Base Load Power Hub (BLPH)

60% 3D Model Review Report

Document Number: 123A90-DDL-PP-RE-70009

BLPH - 60% 3D MODEL REVIEW
ACTION ITEM REGISTER

MR60-TAG01

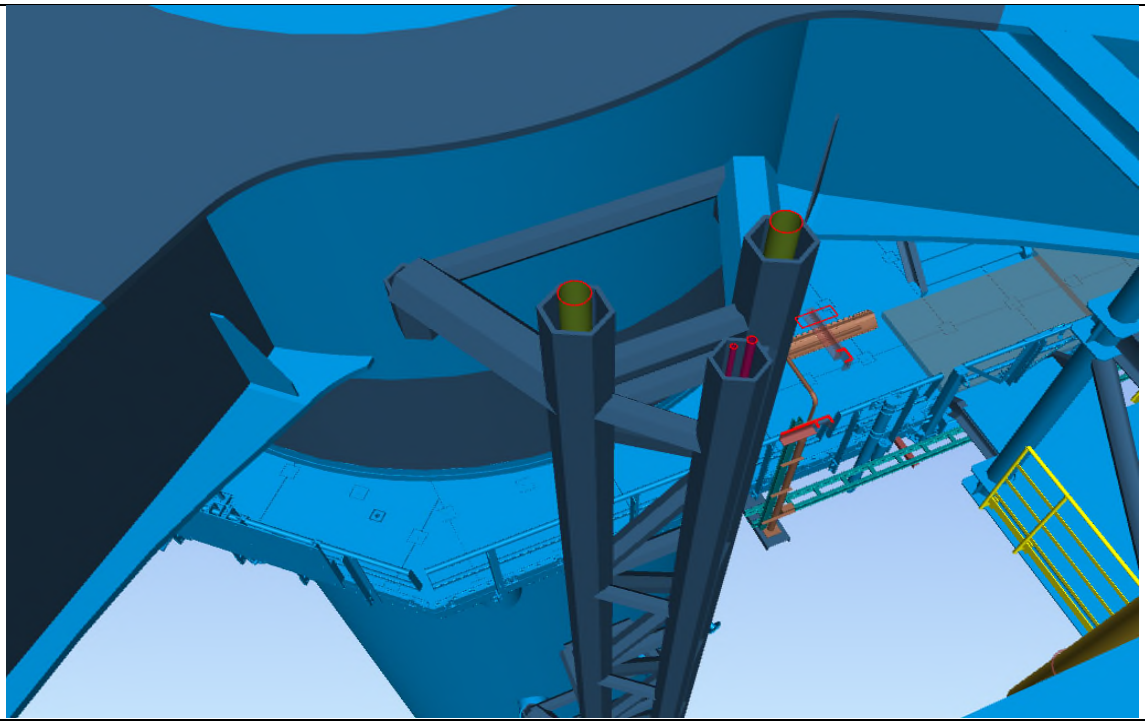
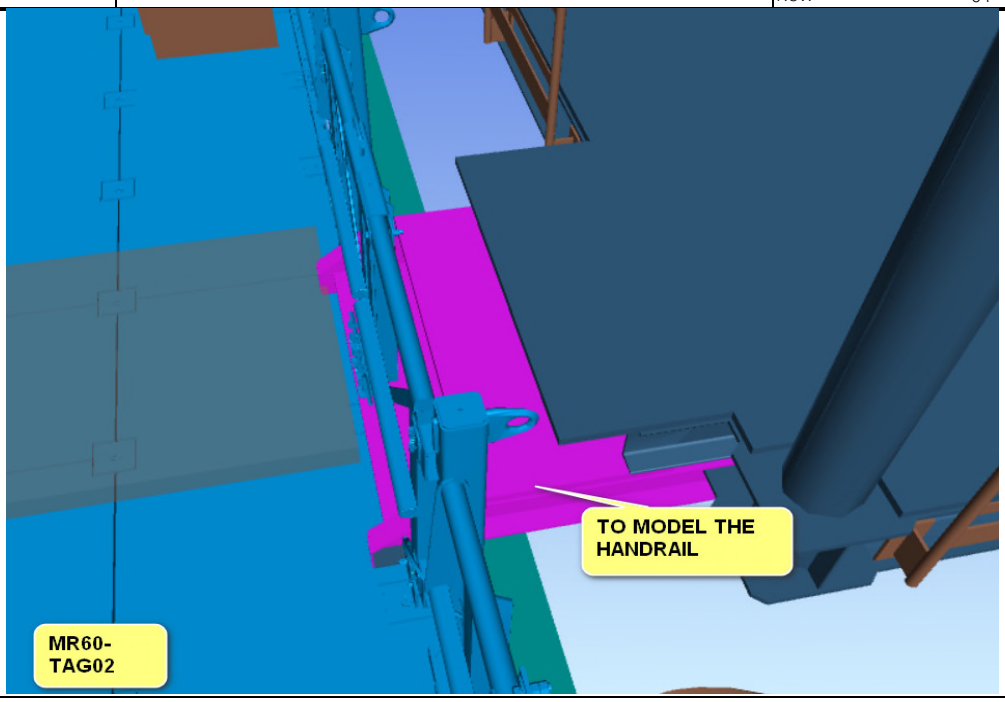
To show sleeves of caissons

Caissons have been modeled

MR60-TAG02

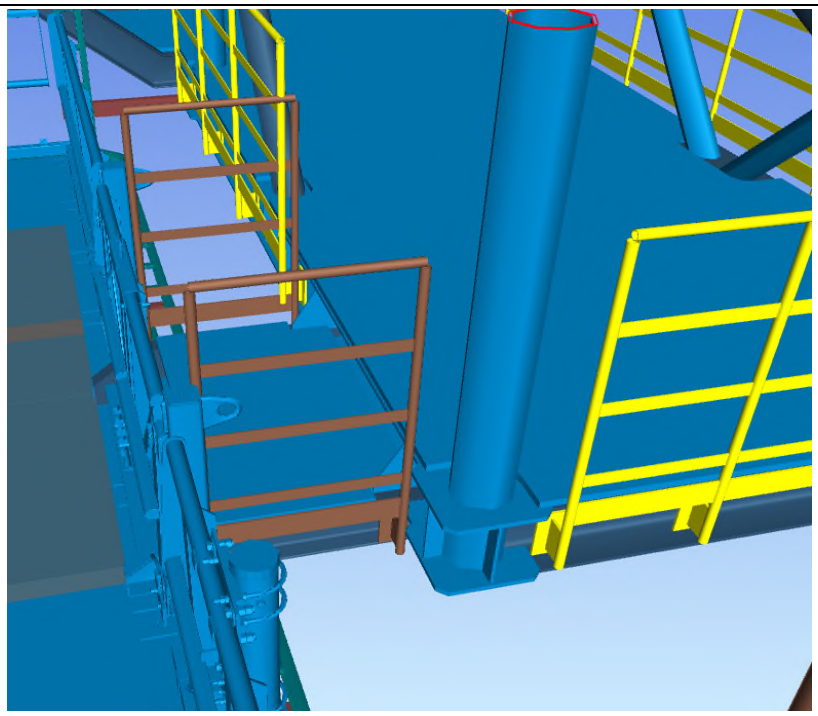
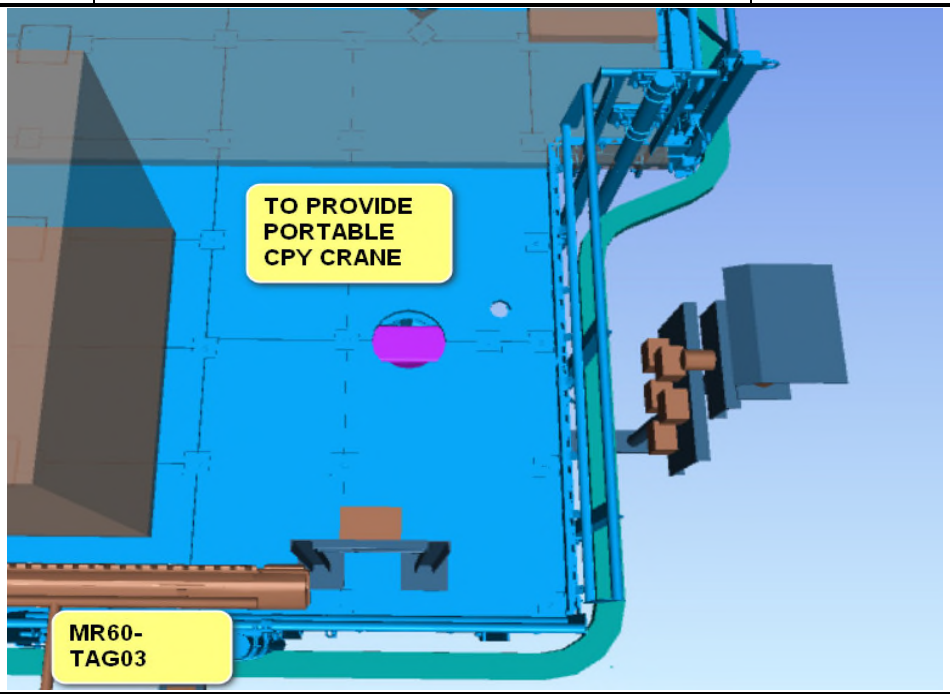
To model the handrail

Handrail has been modeled

MR60-TAG03

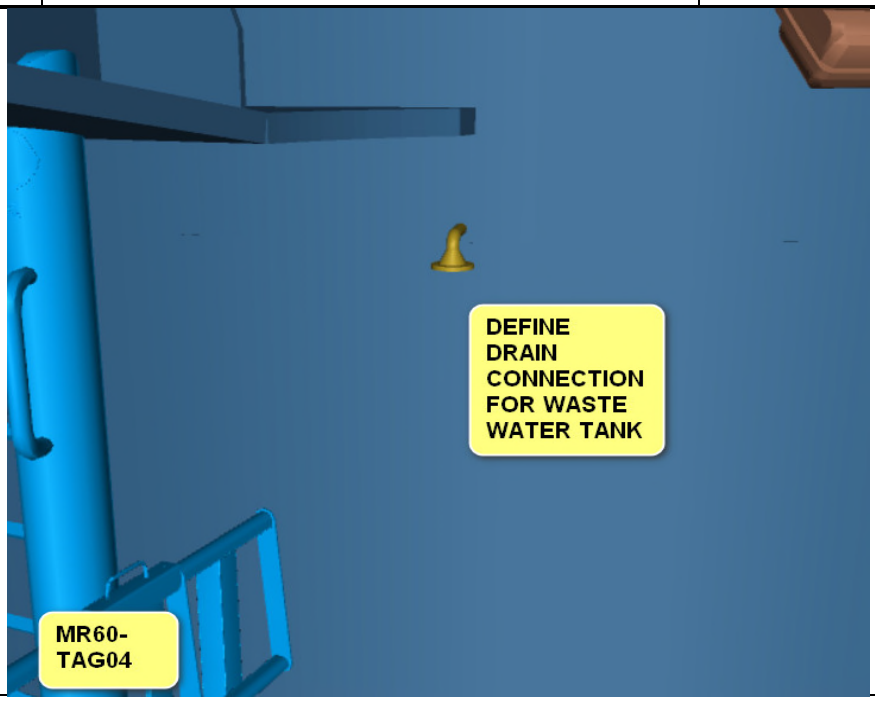
To provide portable CPY Crane

Temp Crane has not been modeled since with the fixed crane any thing can be lifted on the platform.

MR60-TAG04

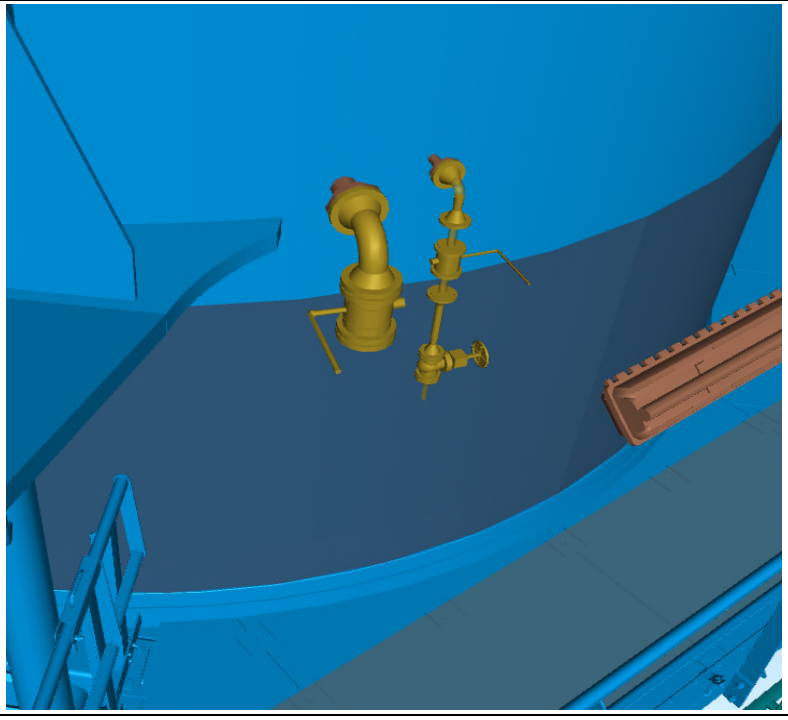
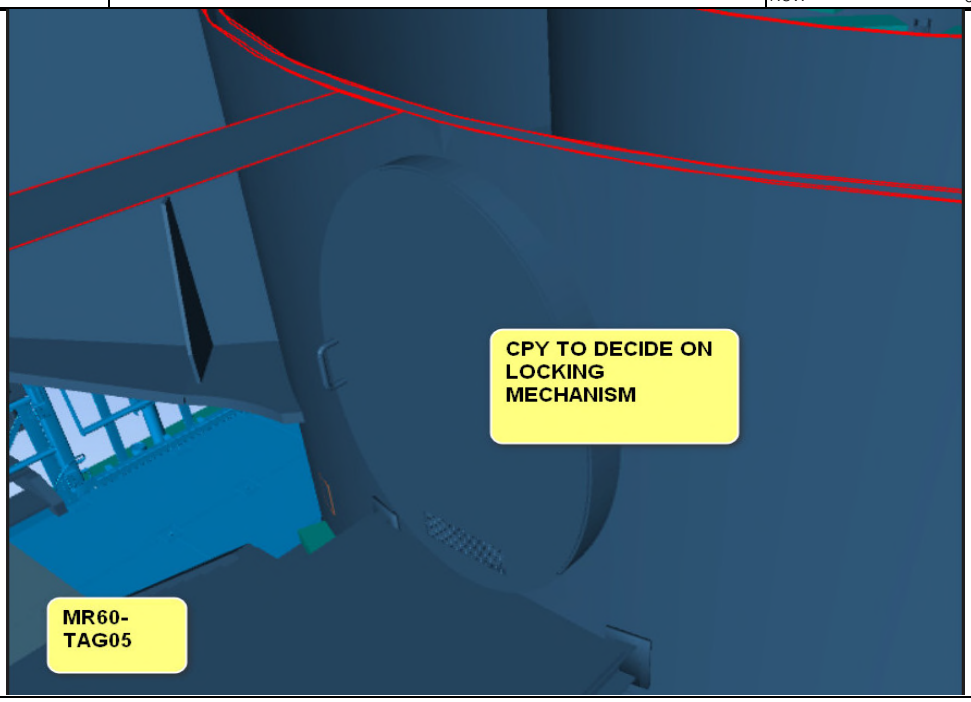
Define drain connection for waste water tank

Drain configuration has been defined by ROS: 3" ball valve with blind flange has been provided in accordance with the latest revision of the P&IDs.

MR60-TAG05

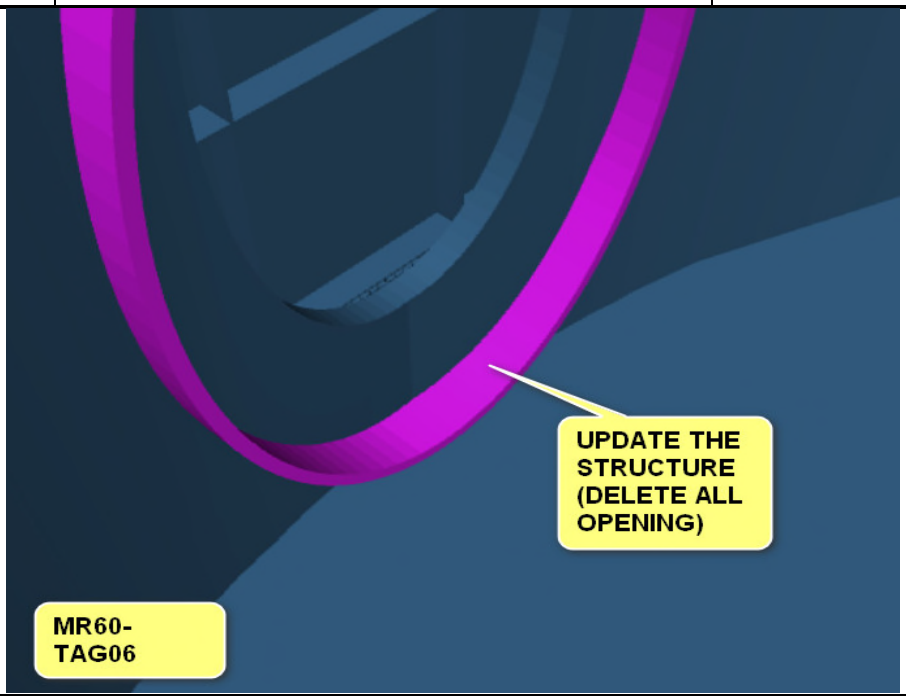
CPY to decide on locking mechanism

(27/05/2024) CPY proposal is to use the same design as for the HNK CW WTG door (Siemens Gamesa, ref to below screenshot) where a padlock is on the external of door for locking purpose.

1. A LOTO procedure to be defined and implemented to ensure nobody is accidentally locked in.

2. Locking device on the handrail to be included to keep and latch the door open, ref to the samples "2"

3. A soft closing mechanism on door to be included, ref to sample "3"

Contractor will decide one of the three proposed solution that will be purchased by door vendor.

MR60-TAG06

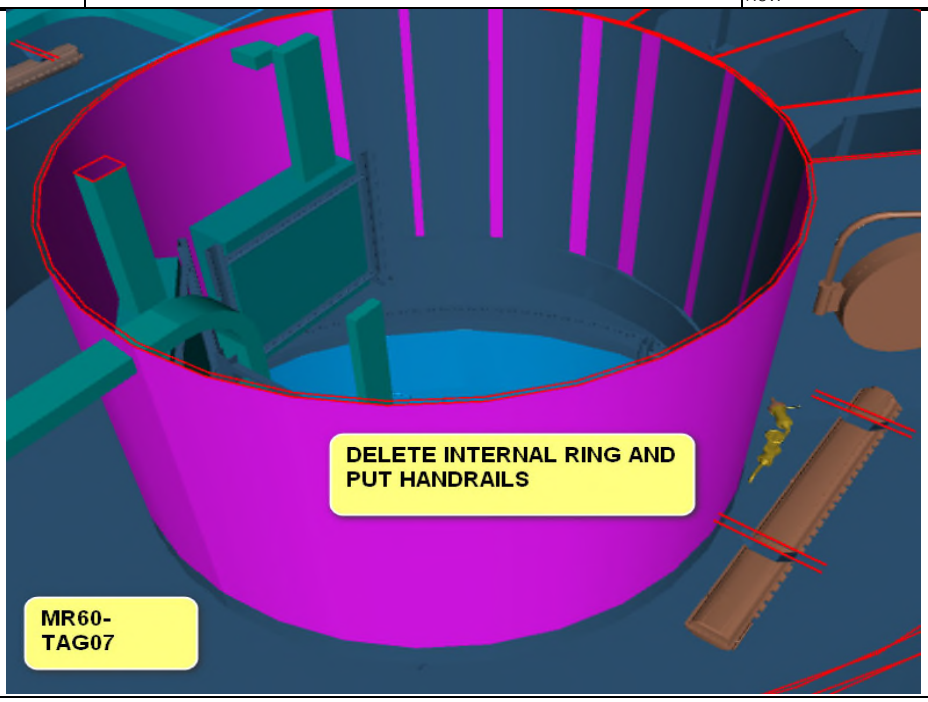
Update the structure (delete all opening)

Opening has been modeled

MR60-TAG07

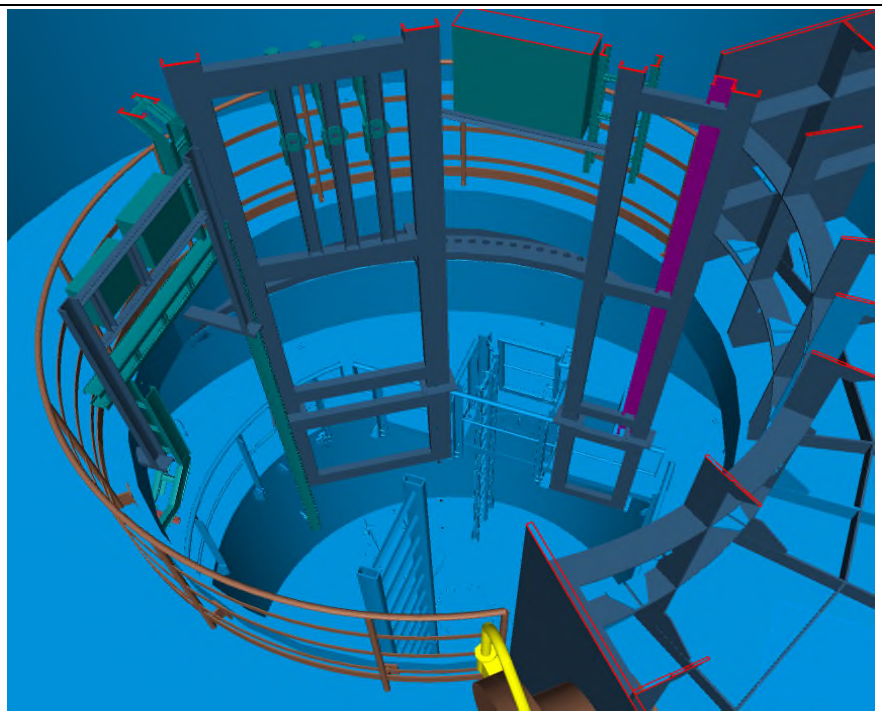
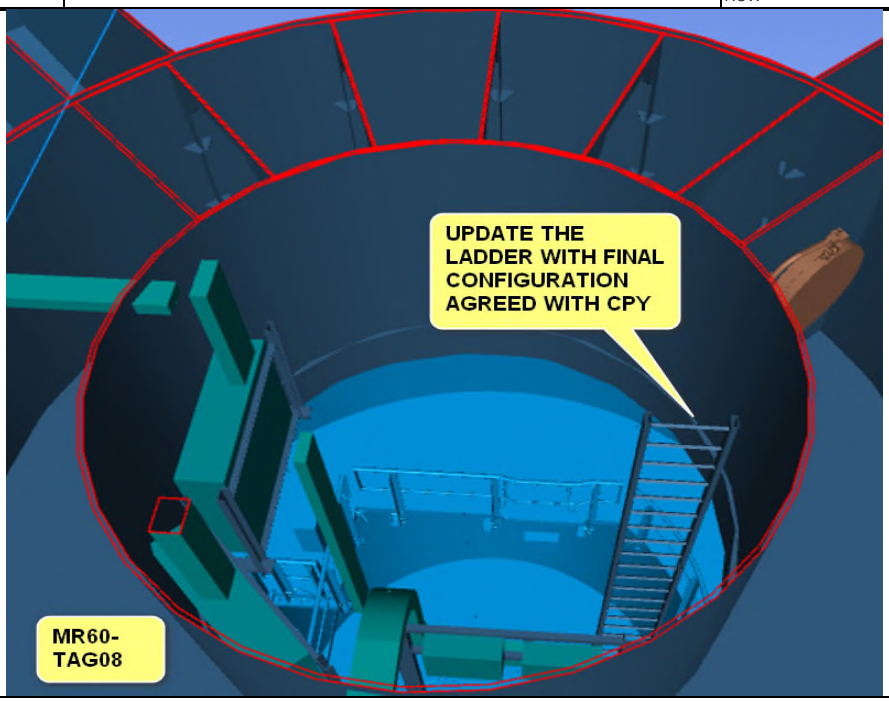
Delete internal rings and put handrails

Handrails have been modeled

MR60-TAG08

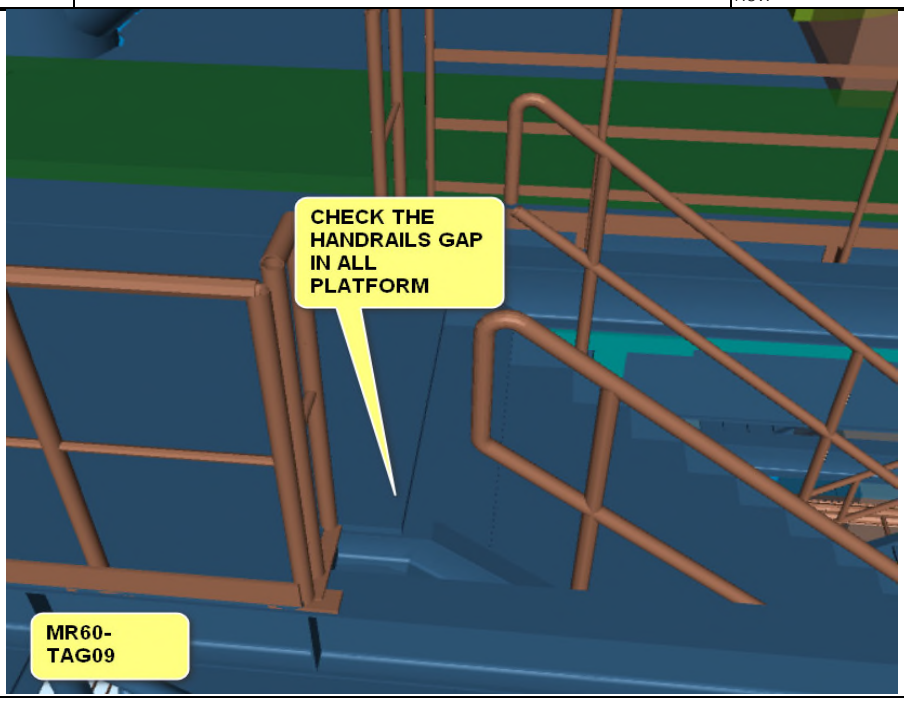
Update the ladder with final configuration agreed with CPY

The ladder is shown in its final configuration

MR60-TAG09

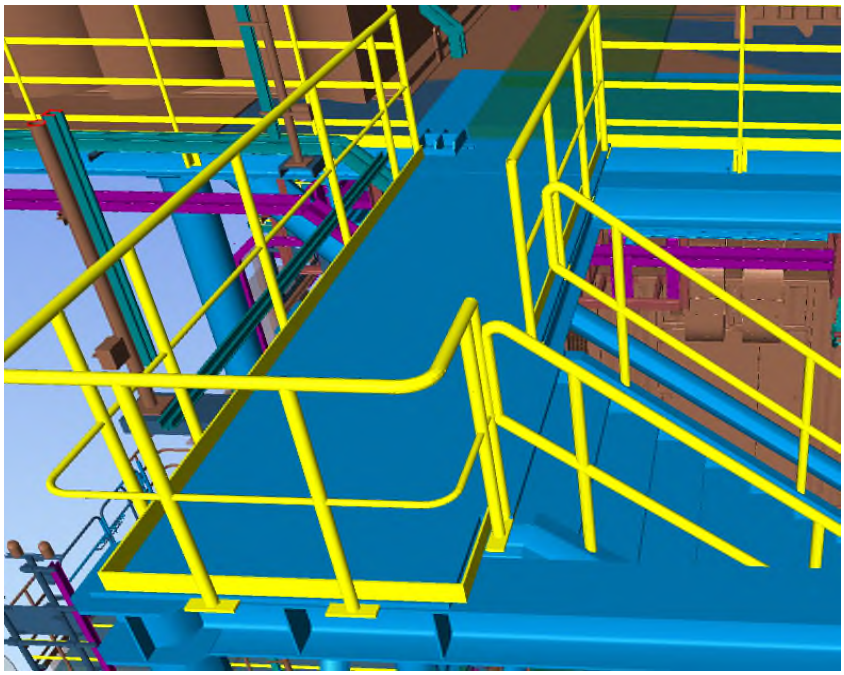
Check the handrails gap in all platform

Handrails gap removed

MR60-TAG10

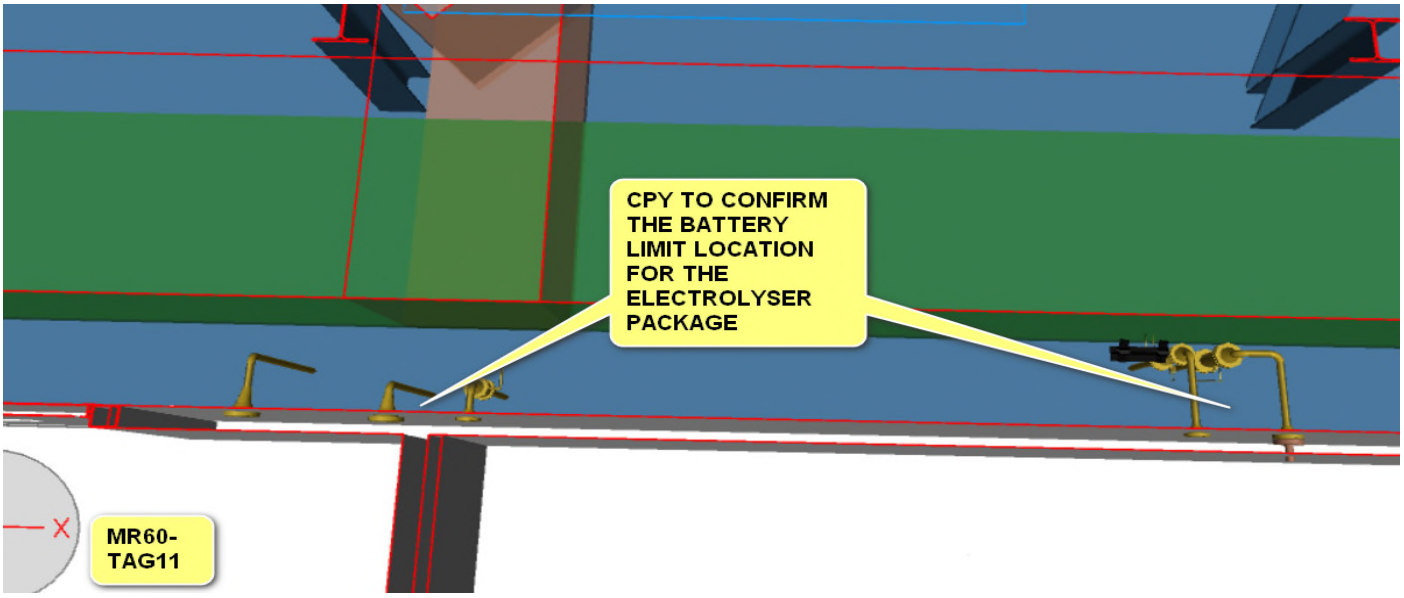
Location of WTW gate to be chosen

The positions of both gates have been defined

MR60-TAG11

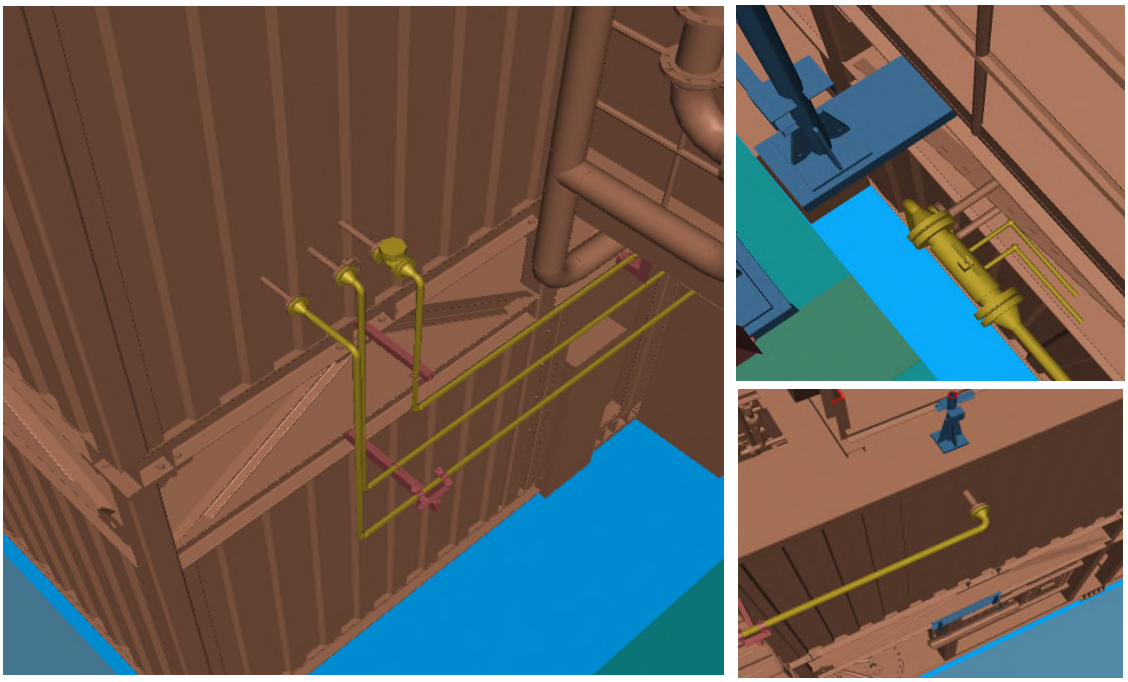
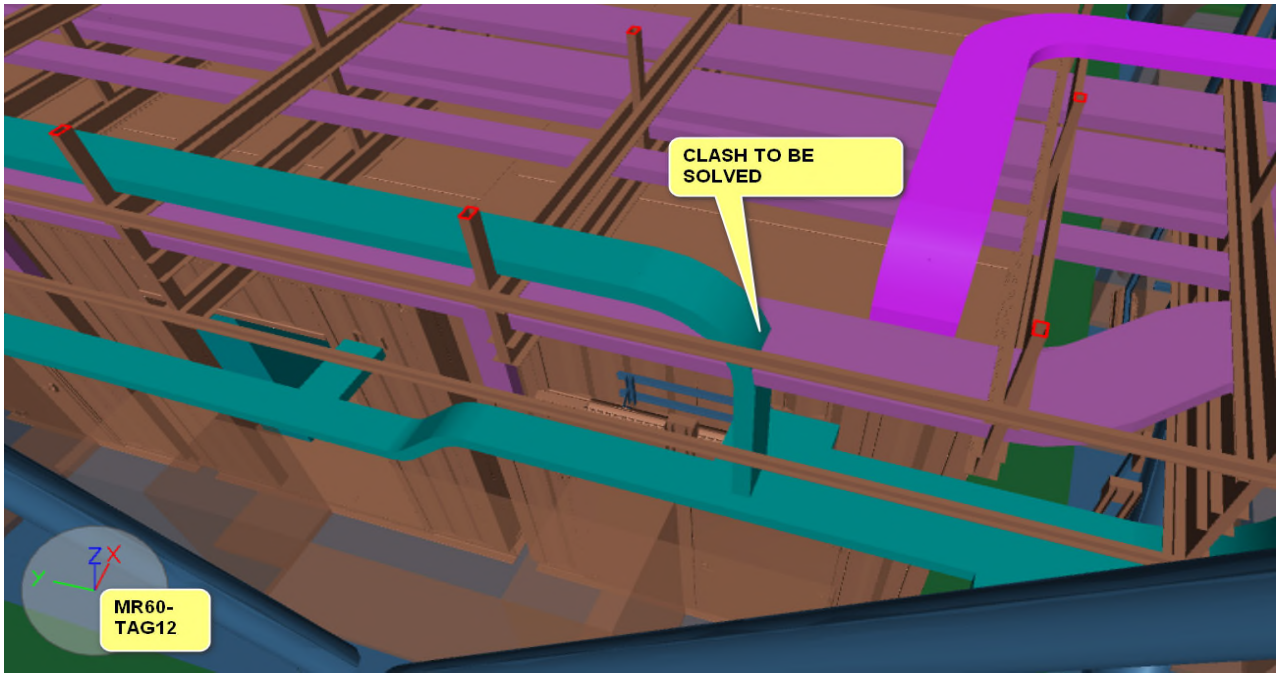
CPY to confirm the battery limit location for the electrolyser package

Battery limits location has been confirmed.
